DOCUMENT 00 90 00
ADDENDUM

ADDENDUM No.: 3

RE: LAC DU FLAMBEAU CHILD DAYCARE CENTER
ADJACENT TO 13708 YOUTH CTR LN (TO THE SOUTH)
LAC DU FLAMBEAU, WISCONSIN 54538
PROJECT NO. 22066

1 FIRST FLOOR FINISH PLAN1
1/8" = 1'-0"

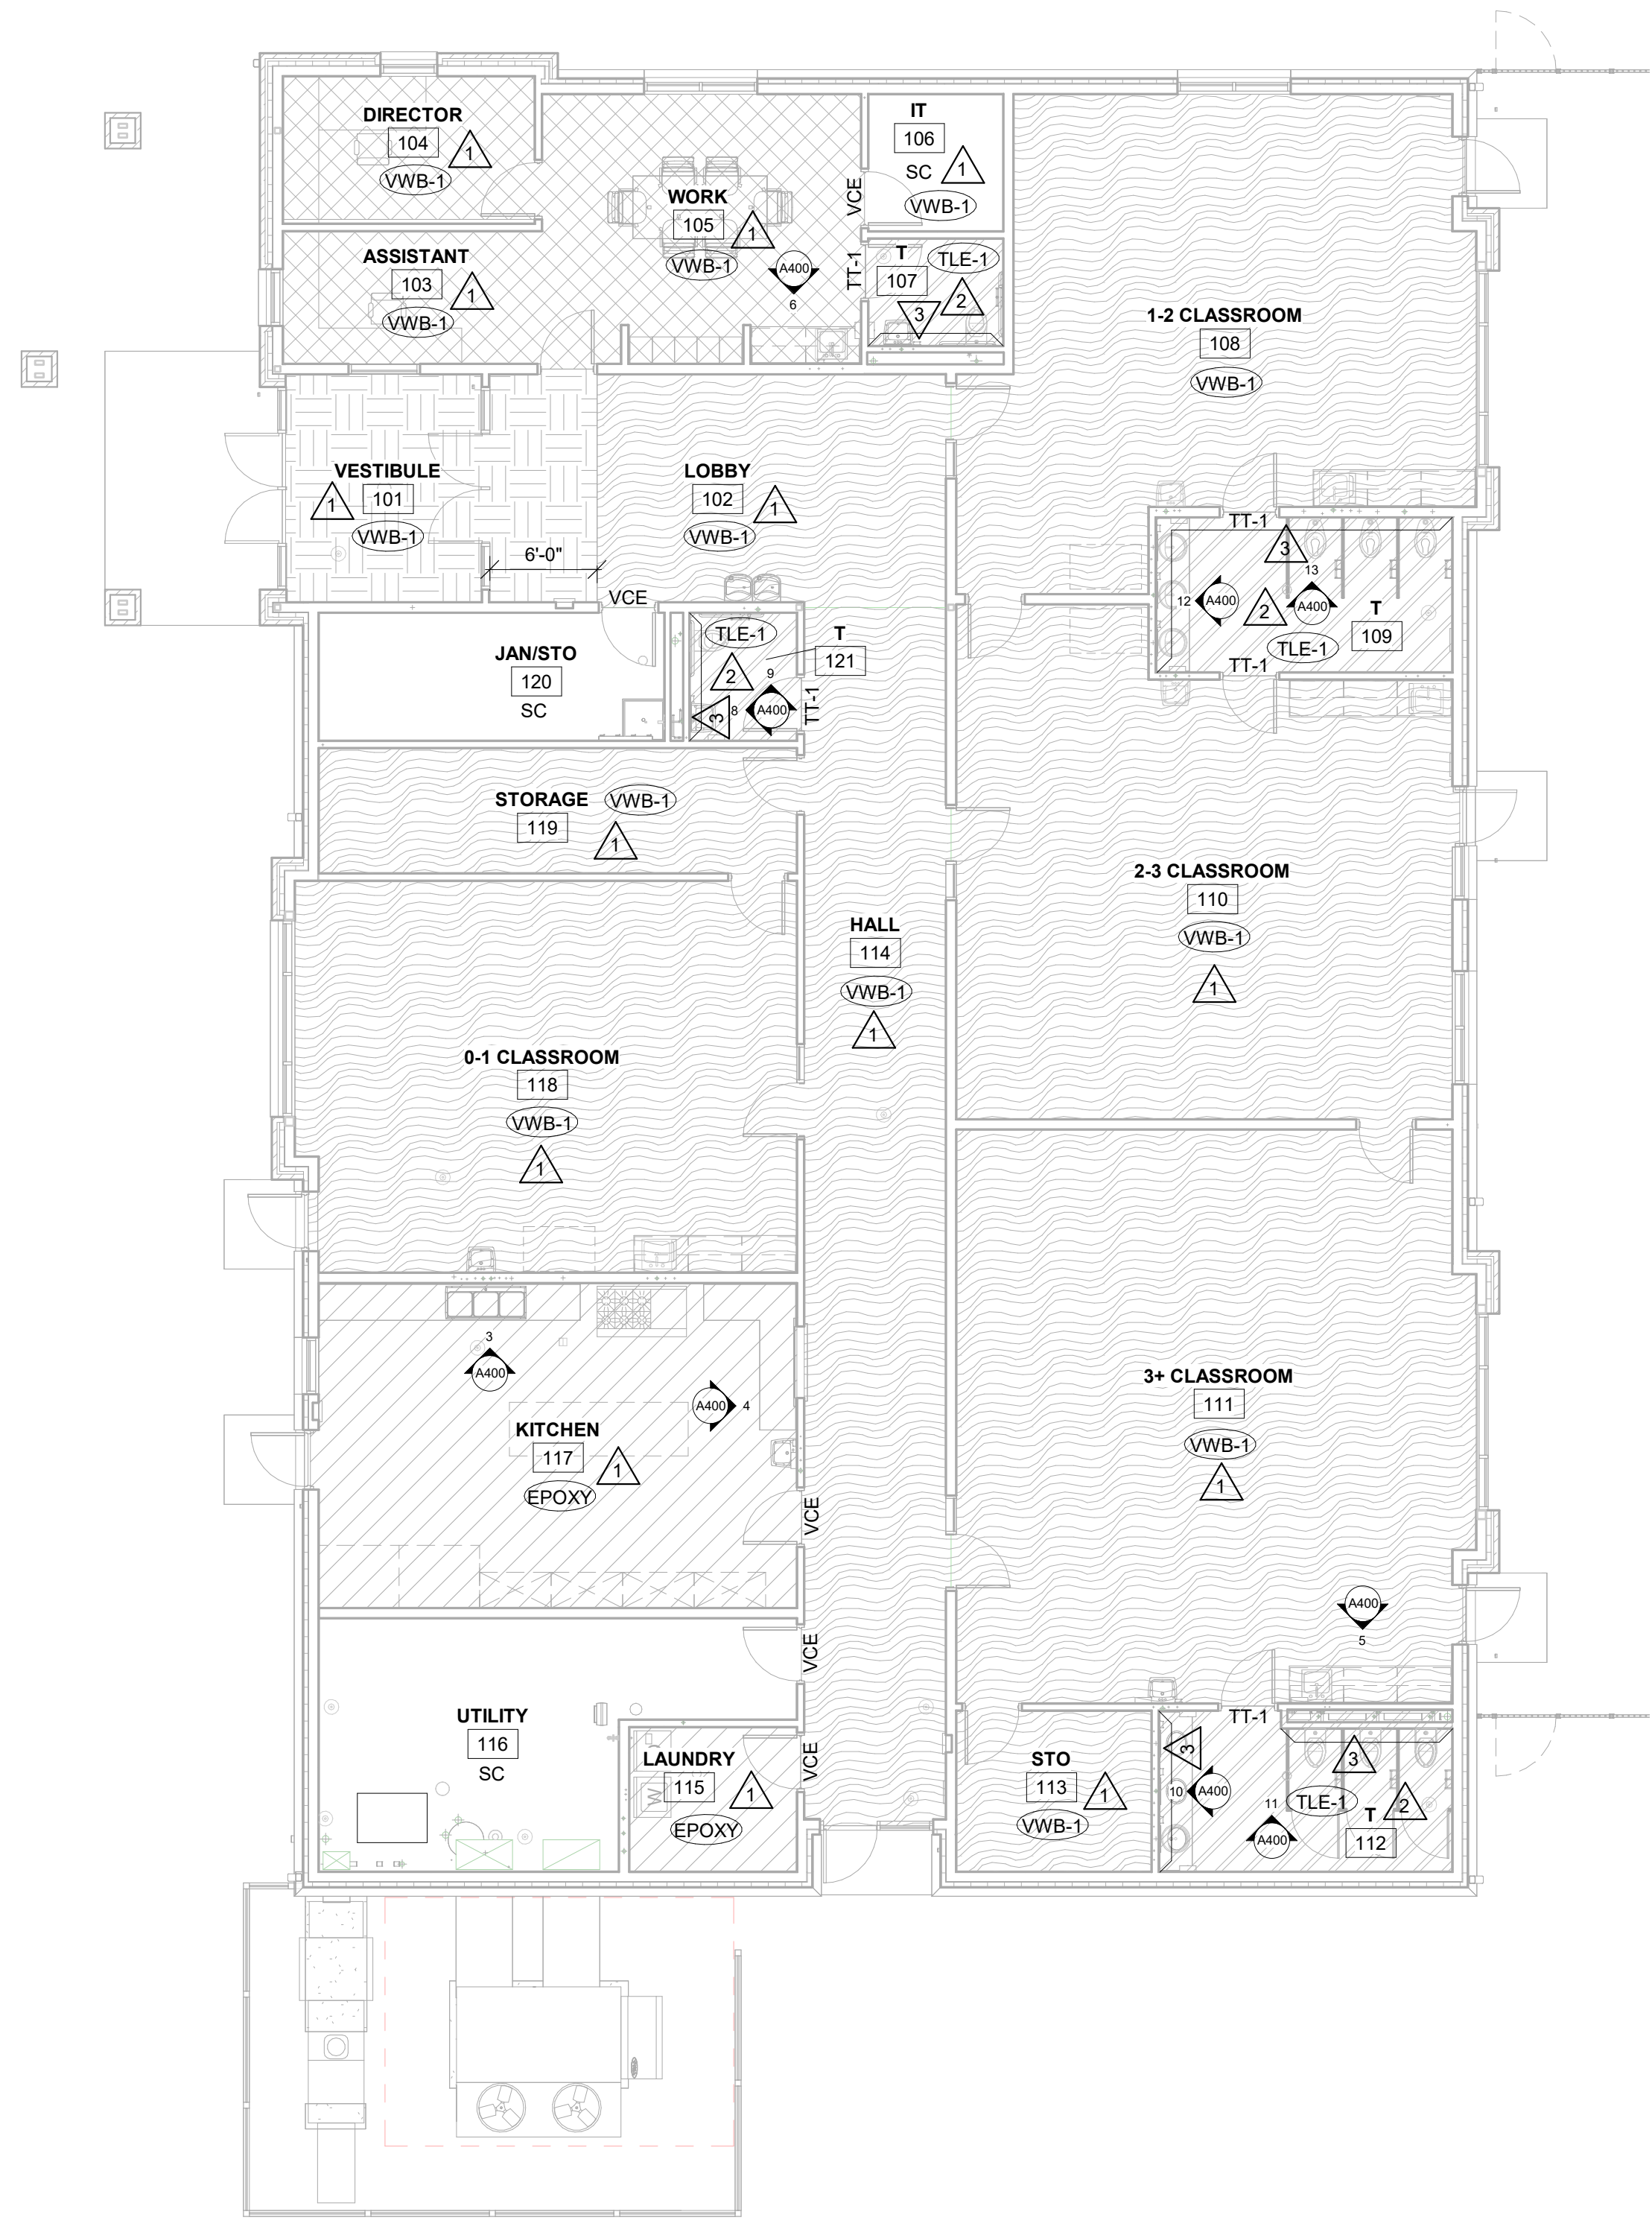
- b. Added Detail 12 showing section view of concrete curb.
11. Sheet ID101 FINISH FLOOR PLAN 30"x42"
 - a. See the revised sheet included in this addendum. Disregard the previous version.

- b. Revised the selections for PLAM and Tile.
12. Sheet P100 FOUNDATION & FIRST FLOOR PLUMBING PLAN 30"x42"
 - a. See the revised sheet included in this addendum. Disregard the previous version.

P100

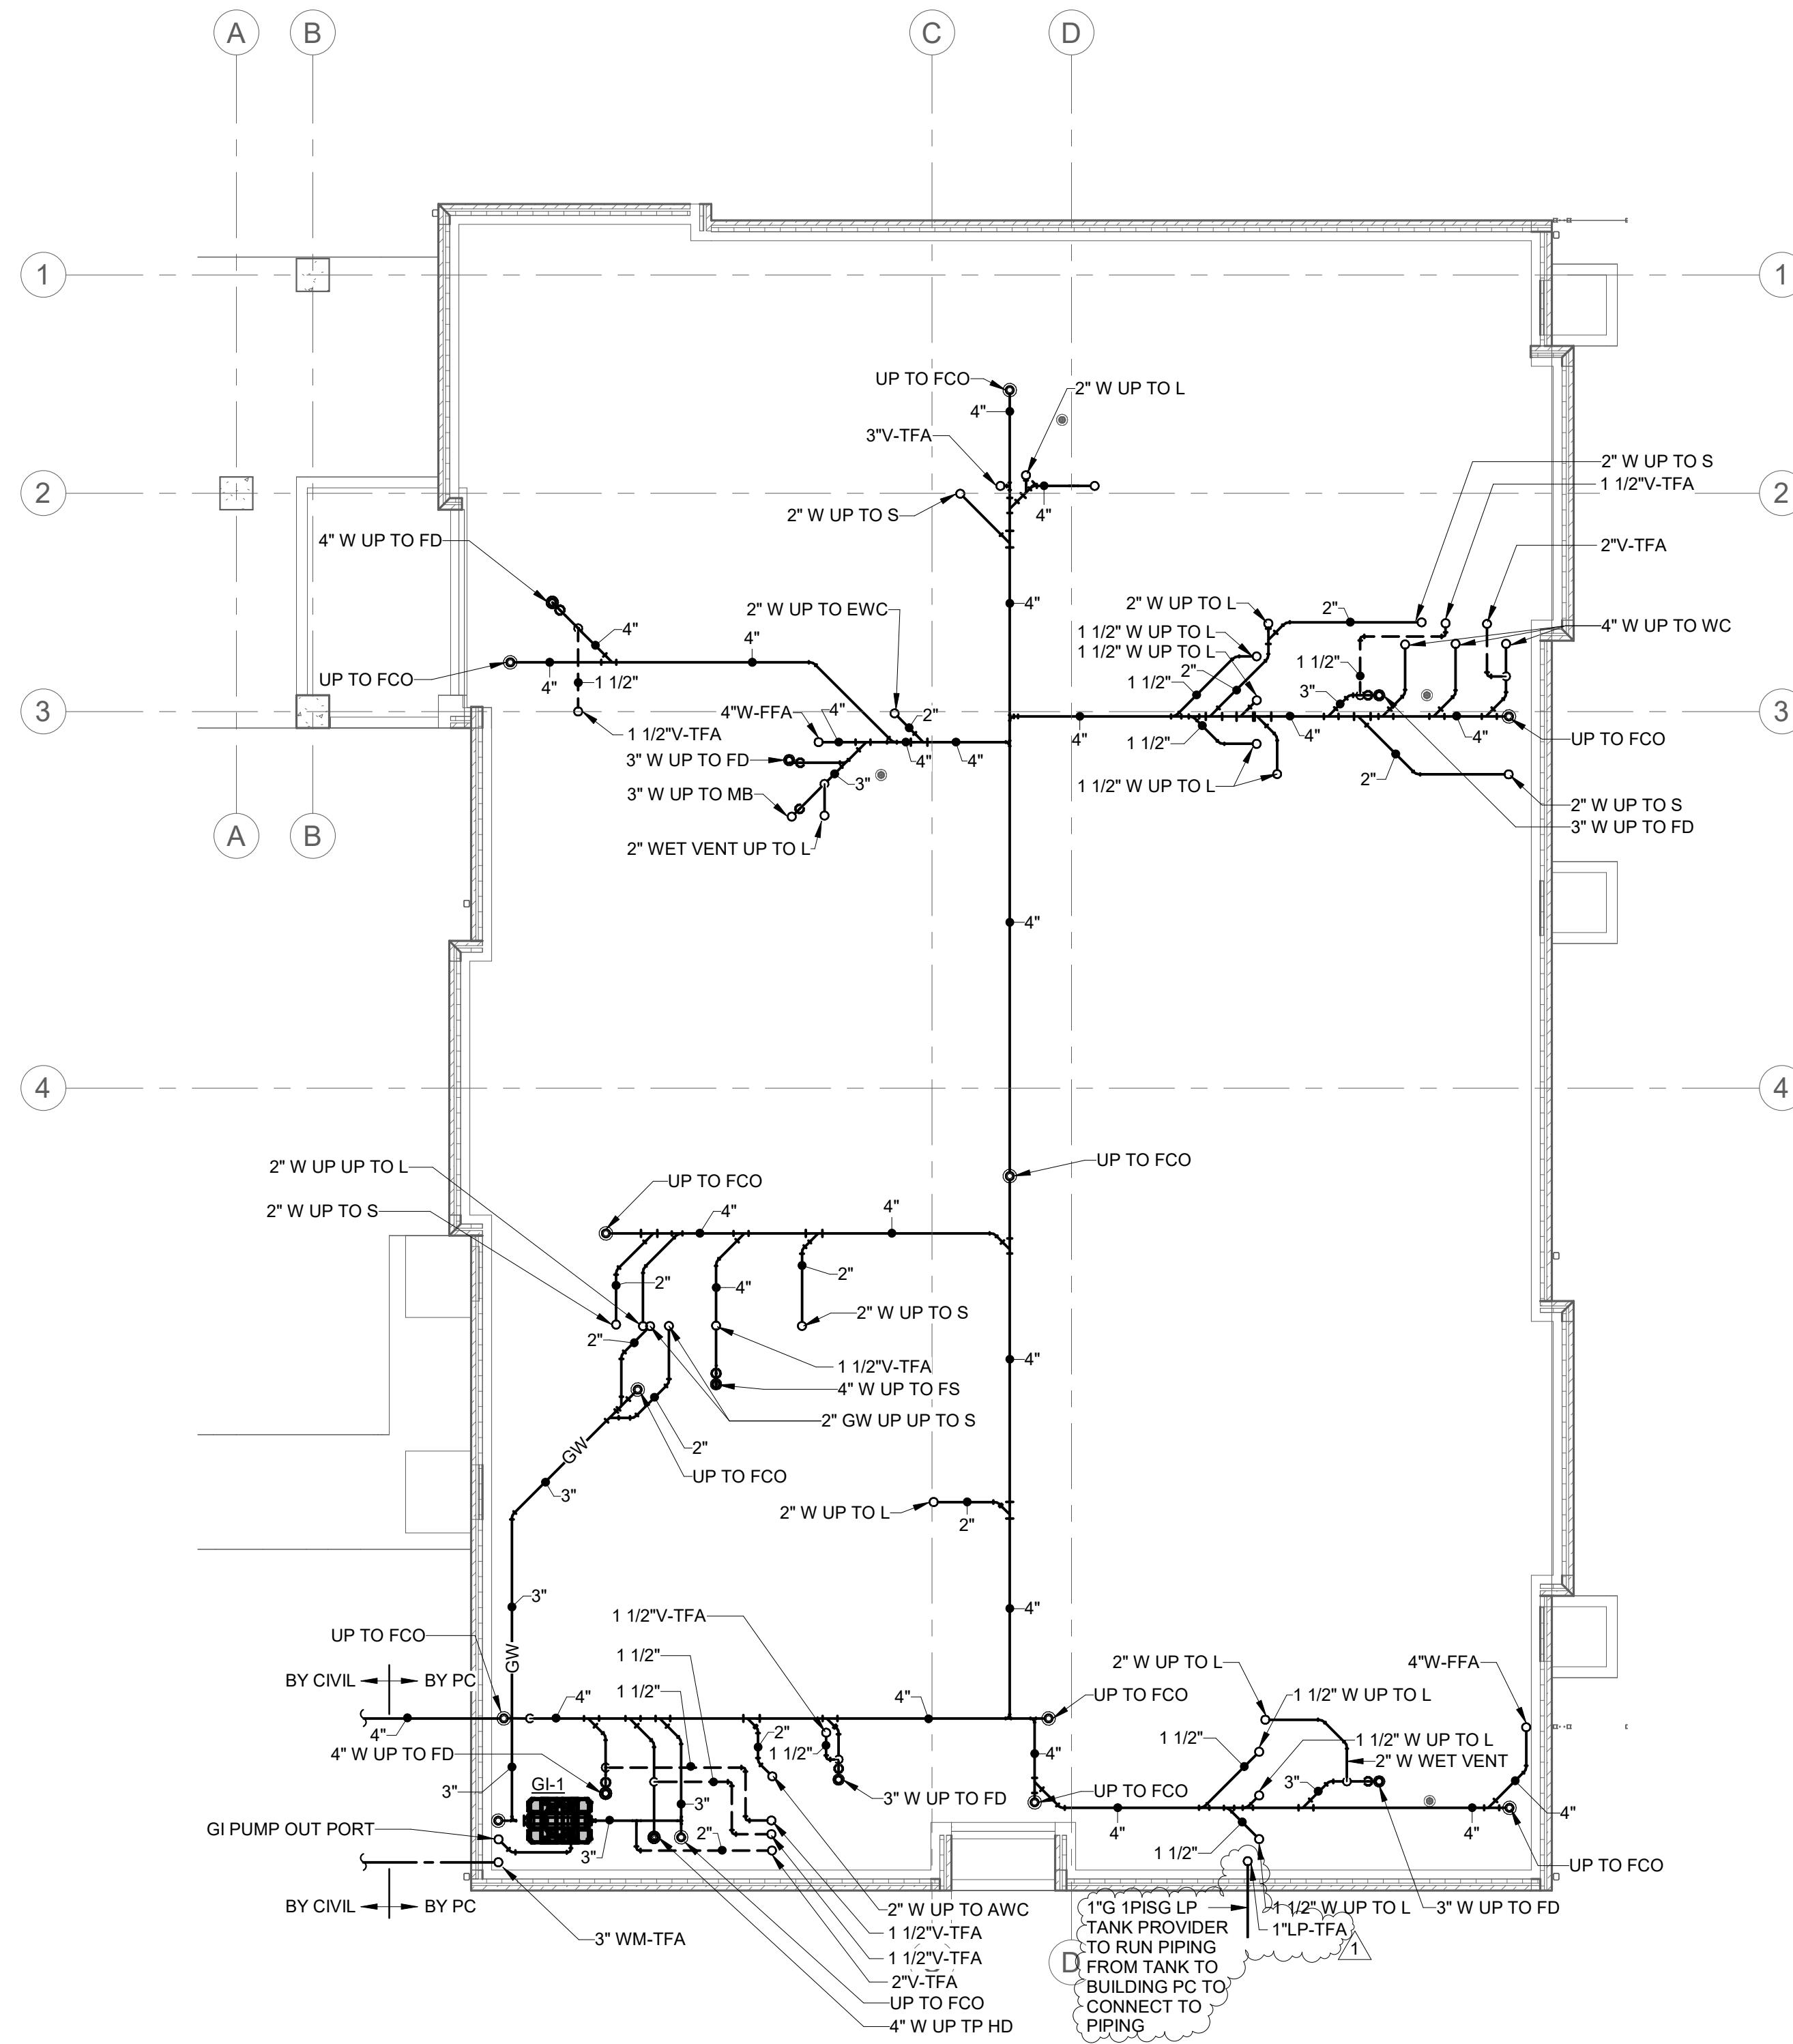
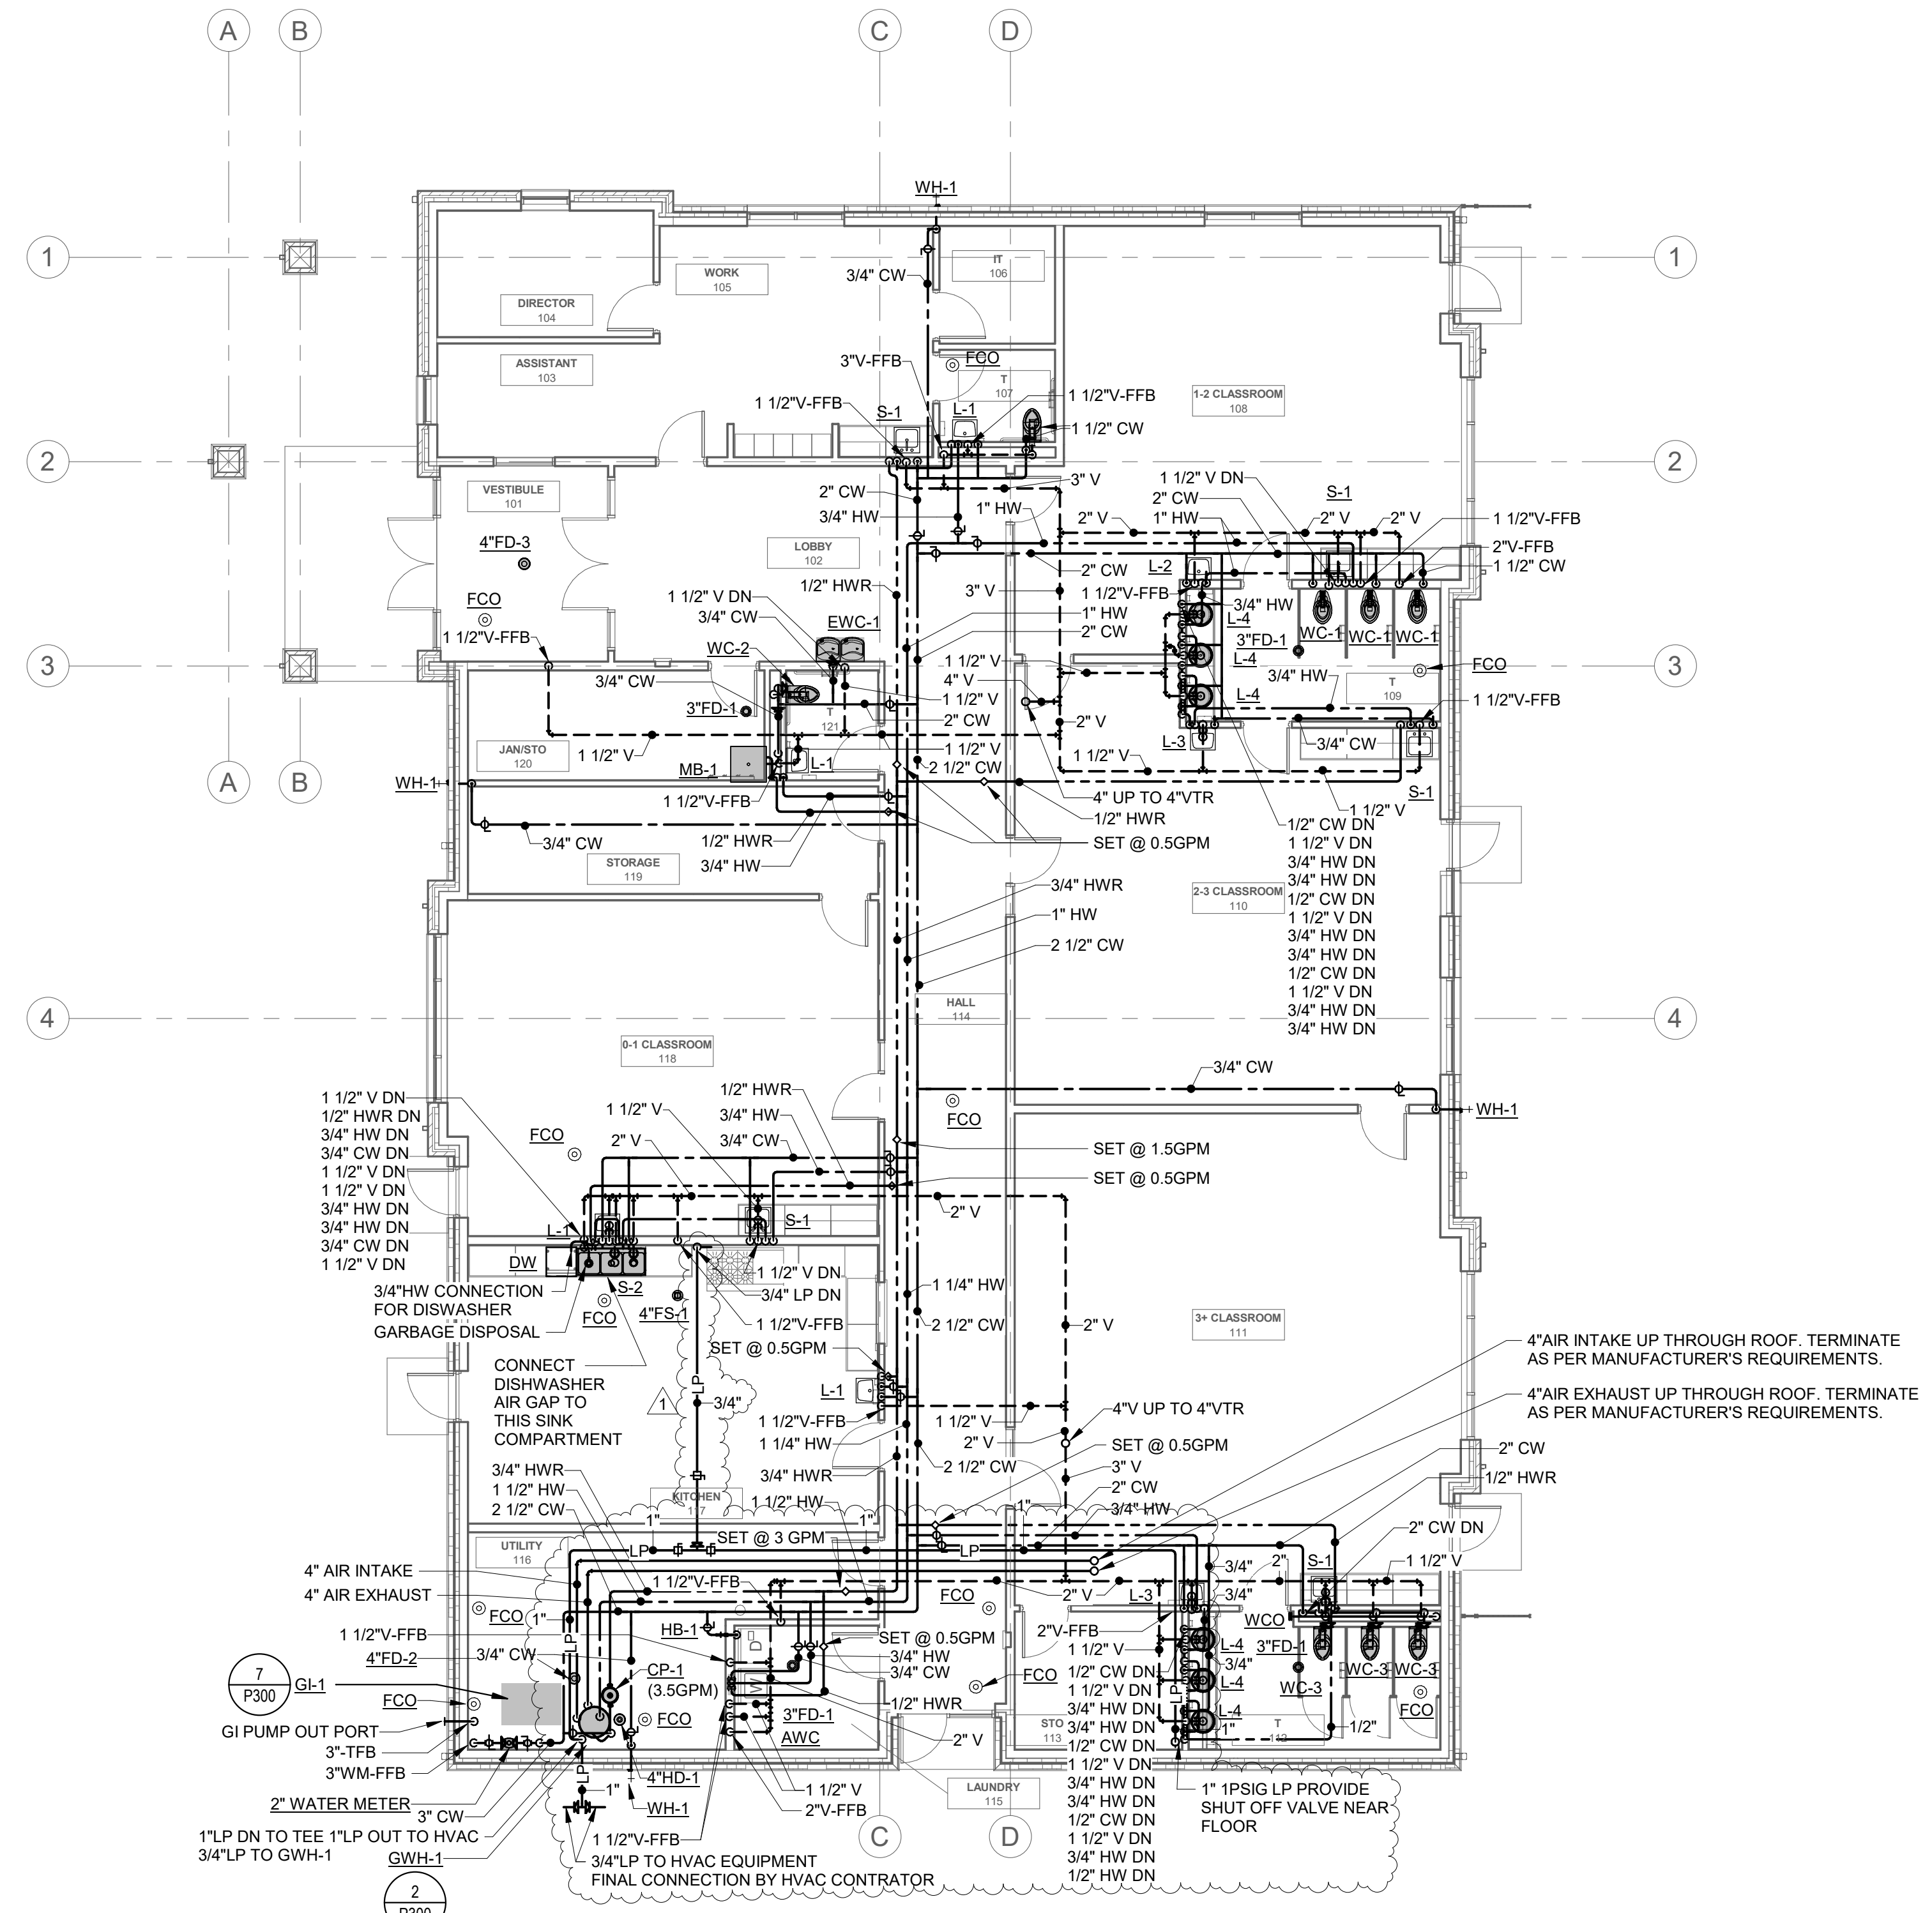
- b. Added piping associated with an added site LP tank.
13. Sheet P400 PLUMBING RISER DIAGRAMS 30"x42"
 - a. See the revised sheet included in this addendum. Disregard the previous version.
